Fire Risk Assessment 53 Groomsbridge Rd

Version 4

11 September 2024

Next Assessment Due: 30 September 2025 Risk Score: Moderate Risk Assessor: David Lloyd

Combustibles in the entrance hallway

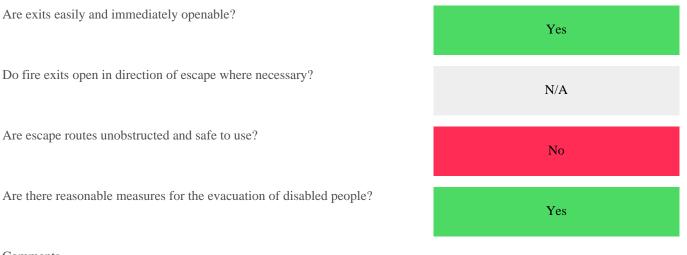
There was a significant volume of combustible materials found in the entrance hallway which should be removed.

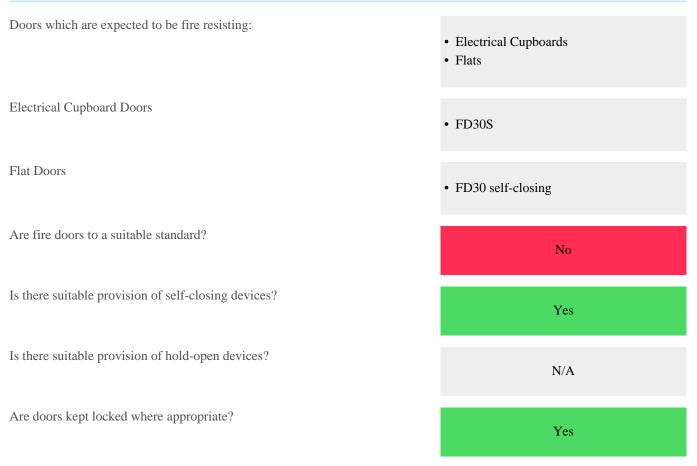
Obstructions should be removed from the escape routes in the entrance hallway.
